Morris Goding  
Access Consulting

Doran Drive Precinct -  
Doran Drive,  
Castle Hill NSW

**Access Review –  
Final v2**

13 July 2021

Figure 2. Level 2 access to Residential Podium

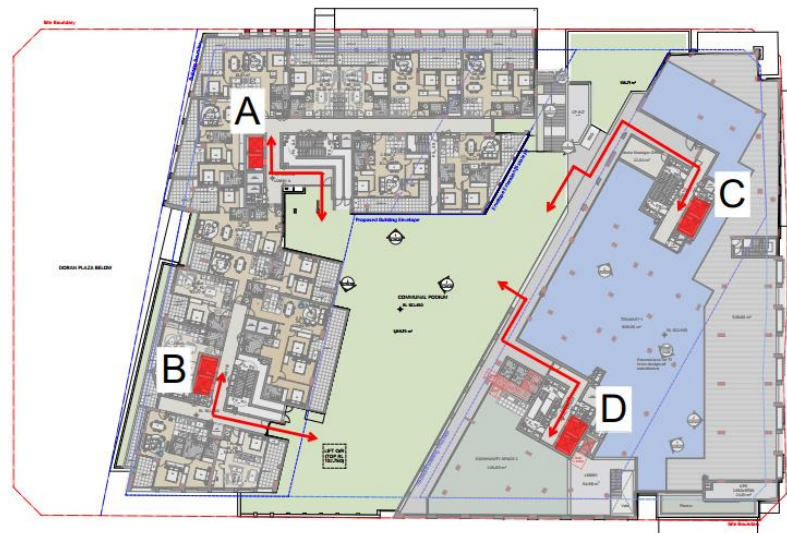
Residential communal podium access achieved accessibility from each lobby of towers A, B, C & D) at level 2.

Landscape architect is to ensure that the continuous accessible path of travel (inside/outdoor) is compliant with AS1428.1 Clause 6 and 7. Pathways link intersections are to provide compliance with AS1428.1 Figure 4.
